## INSTRUCTION TO SERVICE

<b>ITS: 5940</b>	
<b>SECTION:</b>	284 Electrical Panels
<b>WRITTEN BY:</b>	K. Baziuk
<b>SUBJECT:</b>	Rewire DEF Tank Sensor Power.

# ITS5940

**Figure 2: Final Schematic.**

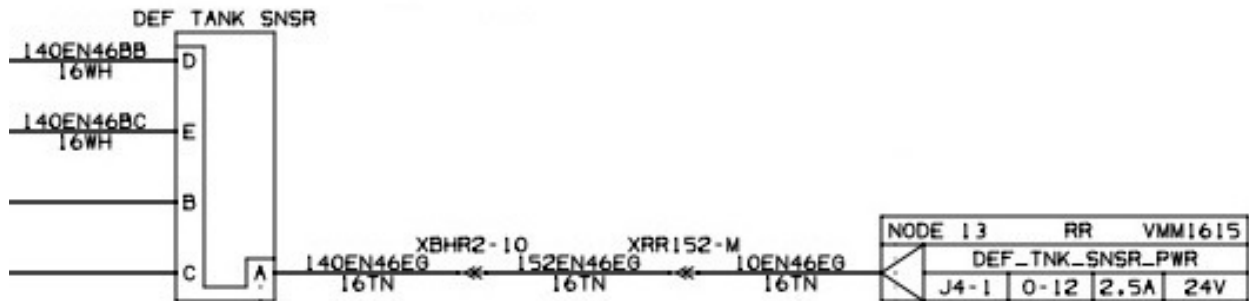
3. Remove existing wire coded 10EN46EG from VMM Node 15; J3, cavity 12 and from the connector XRR152-SHR, cavity M.
4. Crimp socket, PN: 034794 and pin, PN: 034795 to a 6 ft length of 16 GA TAN wire, PN: 129422, coded 10EN46EG. Install wire to VMM Node 13; J4, cavity 1 and to connector XRR152-SHR, cavity M.
5. Install updated VMM program.
6. Turn the main battery disconnect switch to the “ON” position.
7. Return the coach to service.
